RE: JMC Project 20029  
Edward Jones Office  
150 Bedford Road  
Town of North Castle, NY

**Response to Town Comments Submission**

**Town of North Castle Planning Department, July 4, 2020**

**Kellard Sessions Consulting, P.C. Memorandum, dated July 9, 2020**

DRAINAGE AREA MAPS

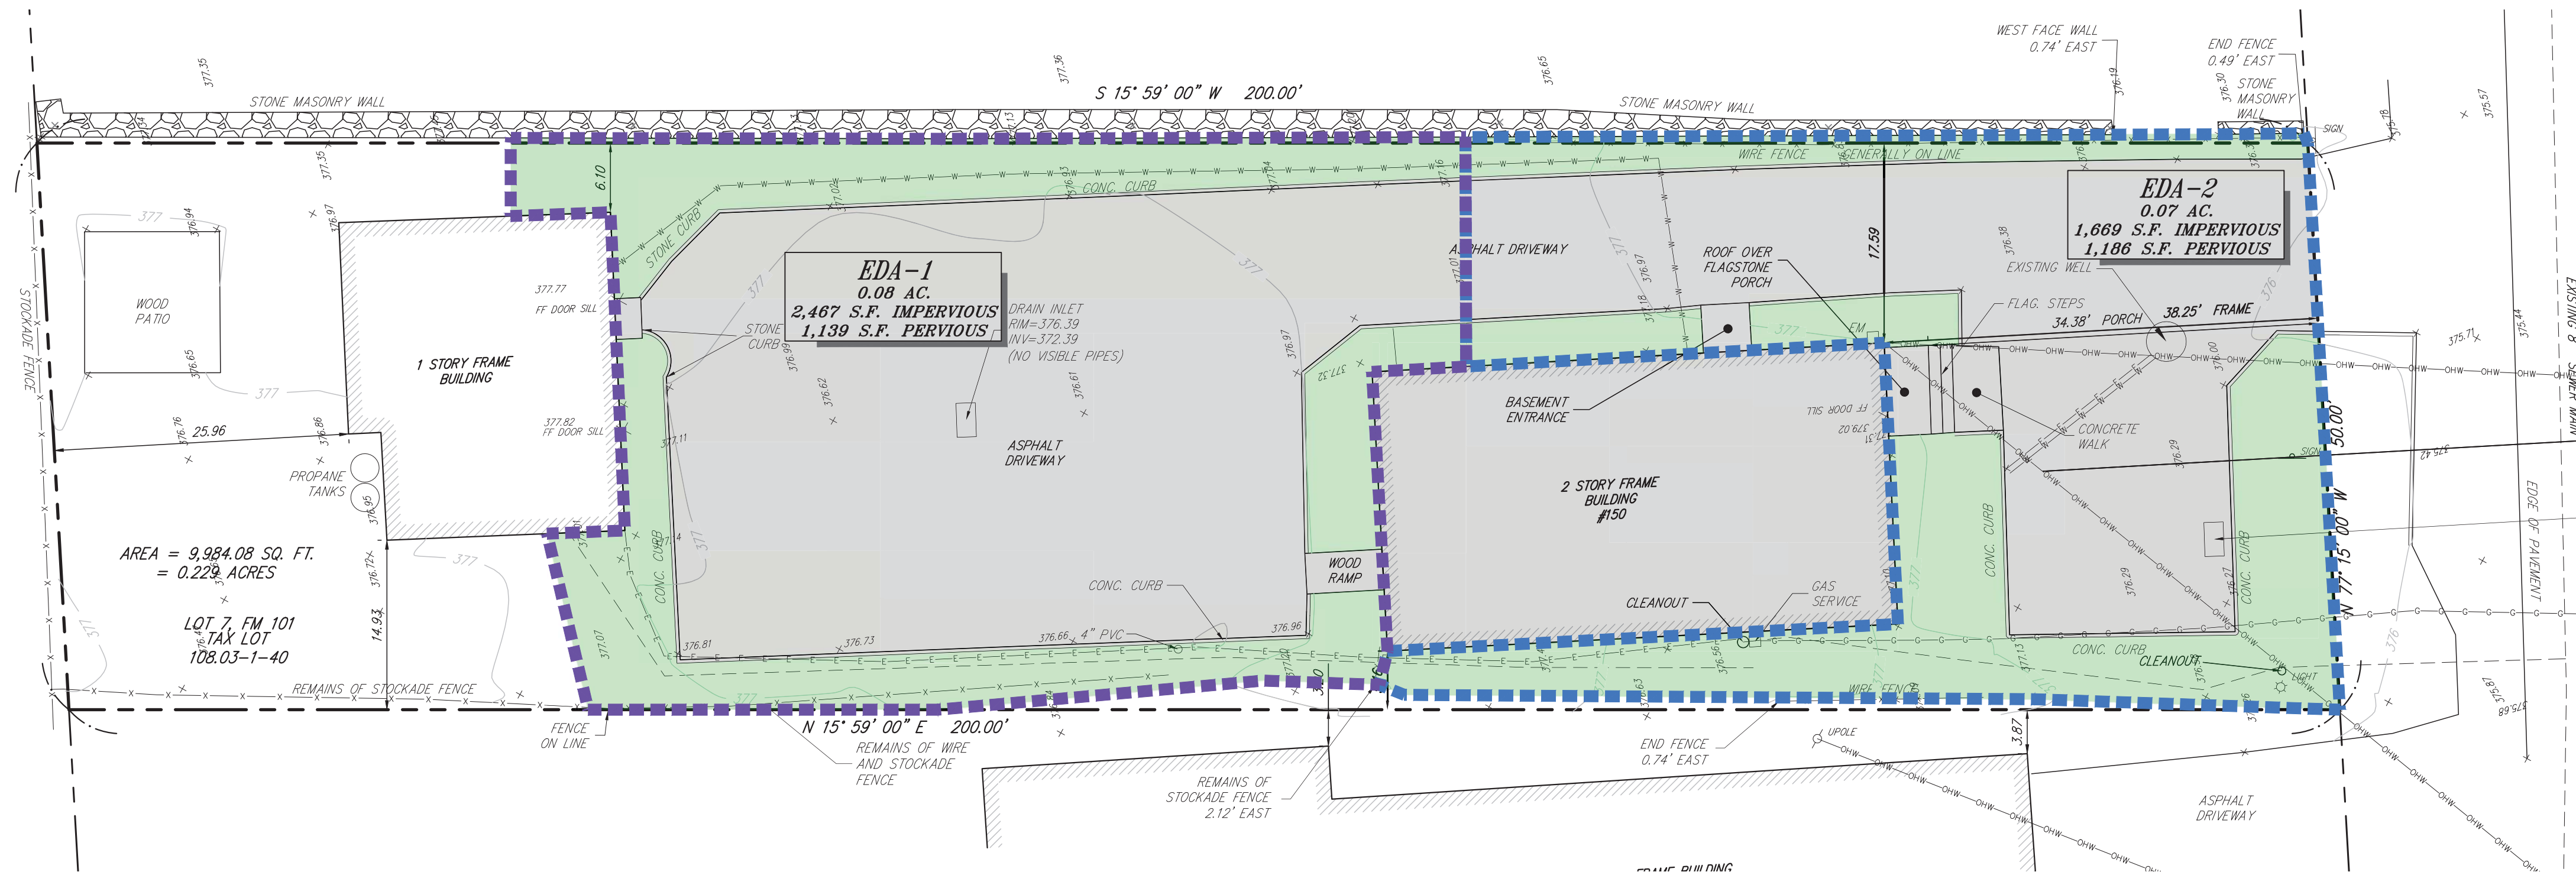
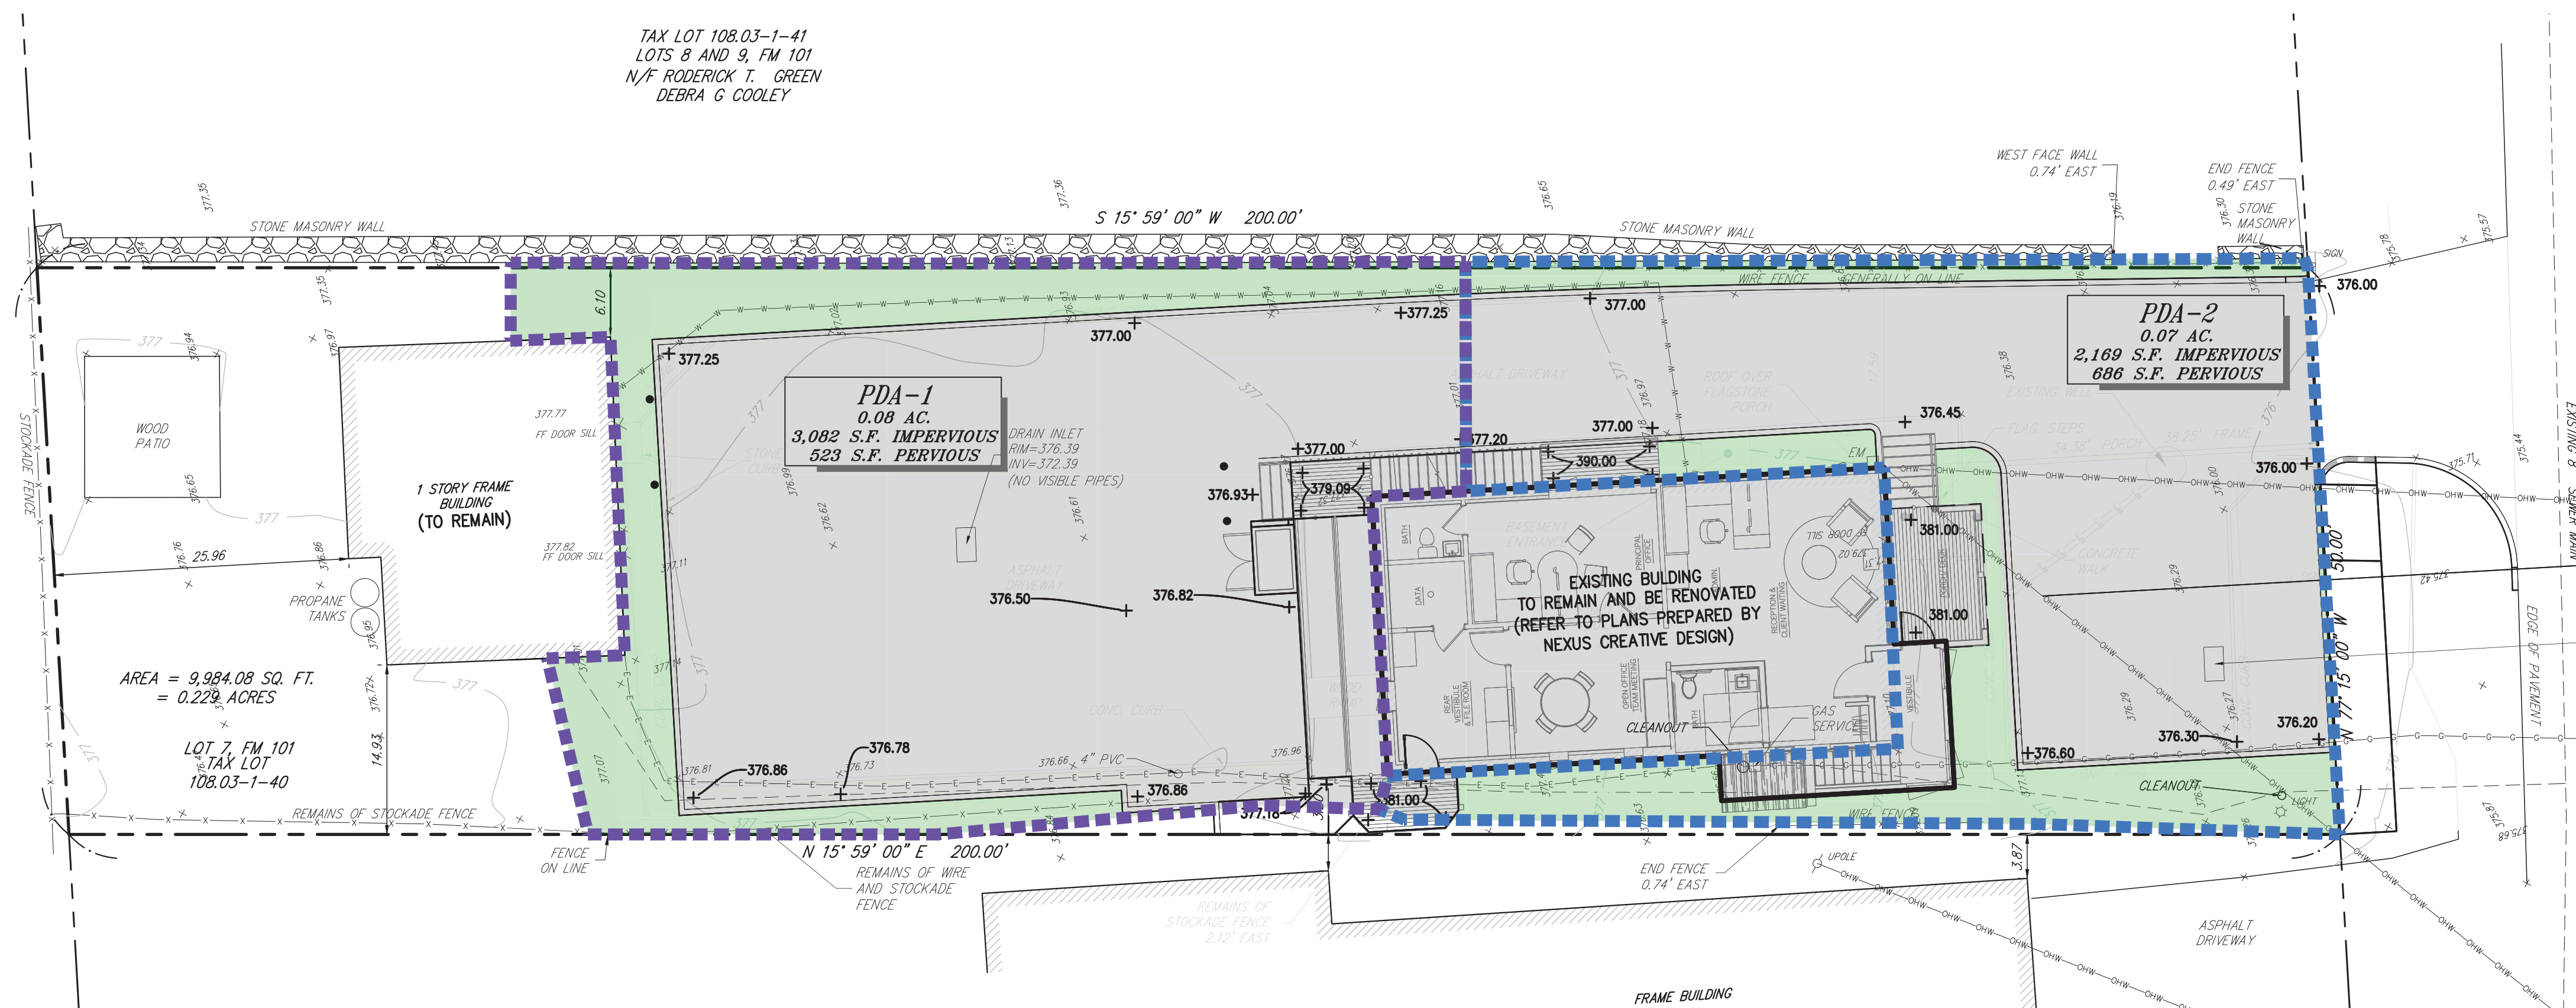
*The plan proposes to reconstruct the existing parking lot and driveway resulting in a net increase in impervious area or approximately 1,025 s.f. The applicant has provided a Stormwater Analysis to demonstrate that the existing infiltration system provides adequate mitigation for the increased area. The Dry Well Design Calculations should be revised to illustrate and quantify the various portions of the buildings and drive which are tributary to each system and provide the supporting calculations for the resulting runoff volumes.*

The Dry Well Design Calculations have been revised to illustrate and quantify the various portions of the buildings and driveway which are tributary to each system and the supporting runoff volume calculations have been provided. Existing and proposed drainage area maps have been prepared which depict the portions of the property tributary to each existing drywell.
